TEAC**TECHNICAL INFORMATION****TASCAM CD-302 / X-9, Base, BLT-IN LED**No. **0220**

TEAC**TECHNICAL INFORMATION****TASCAM X-9, EXT EFFECT Noise**No. **0331**

TASCAM X-9, Change of Main/DSP PCB Assy

**Base, BLT-IN LED**

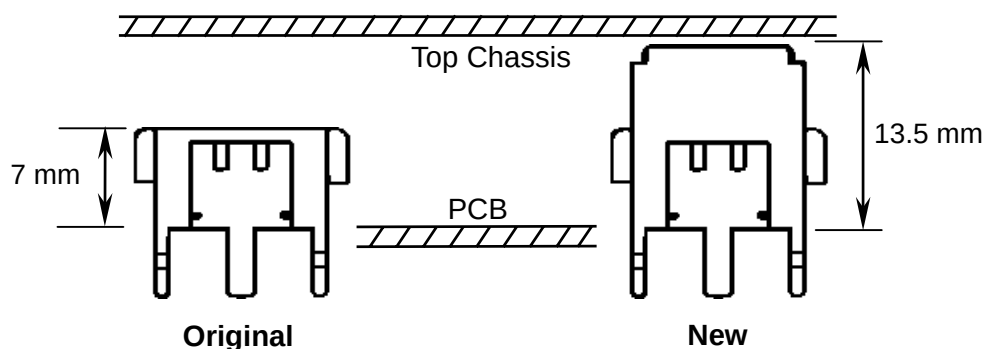
In rare cases, "Base, BLT-IN LED" comes off of PCB.

"Base, BLT-IN LED" is a base for a button mounted on the PCB as shown below.

With the new "Base, BLT-IN LED", its height has been increased to fill up the space between the top chassis.

Original	New
Base, BLT-IN LED	Base, BLT-IN LED (13.5)
P/No. 92602994-00	P/No. 92603960-00

CD-302 S/No. 2700001 and higher

X-9 S/No. 2700001 and higher

On DSP PCB

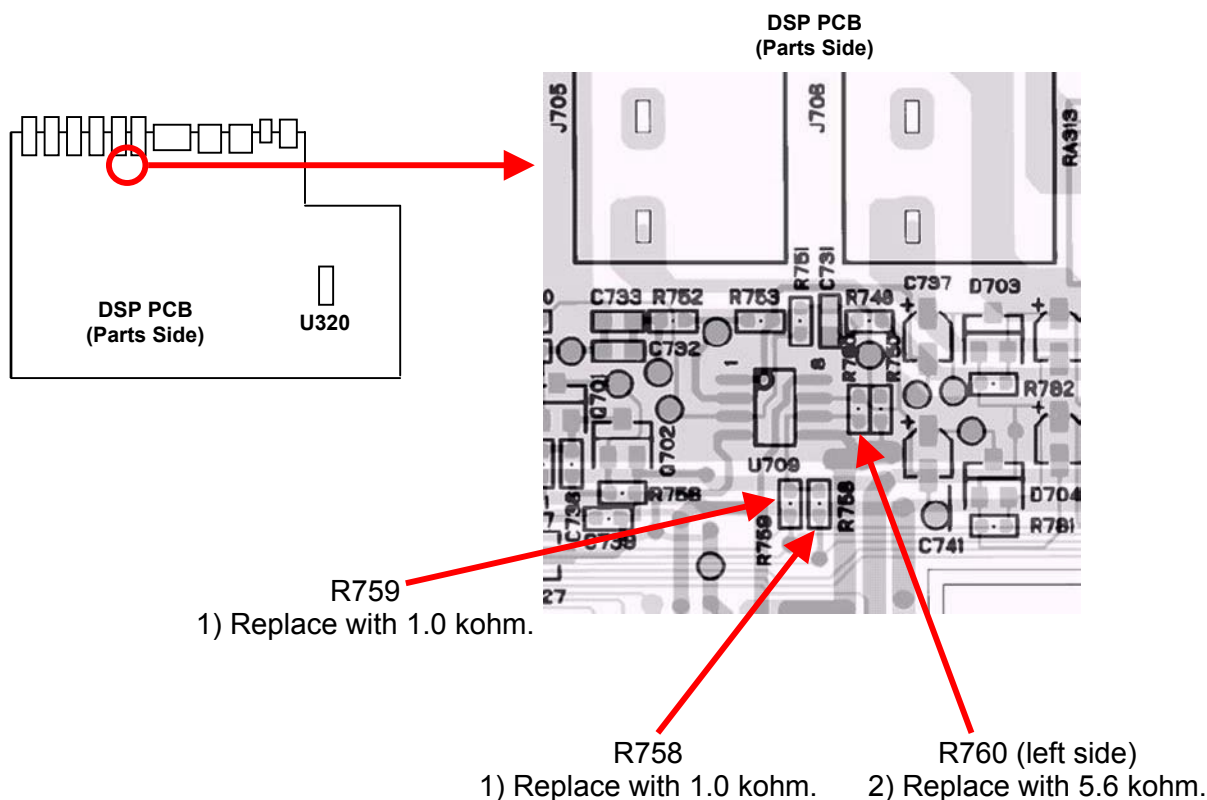
Symptom: Hi-pitched digital noise is heard when MIC or MST is selected to EXT EFFECT mode (EXT EFFECT button lights up) by EFFECT IN rotary switch.

- 1) Replace two R758/759 (33 kohm) resistors with 1.0 kohm (P/No. 91132730-30).
- 2) Replace a R760 (150 kohm) resistor with 5.6 kohm (P/No. 91132910-30).
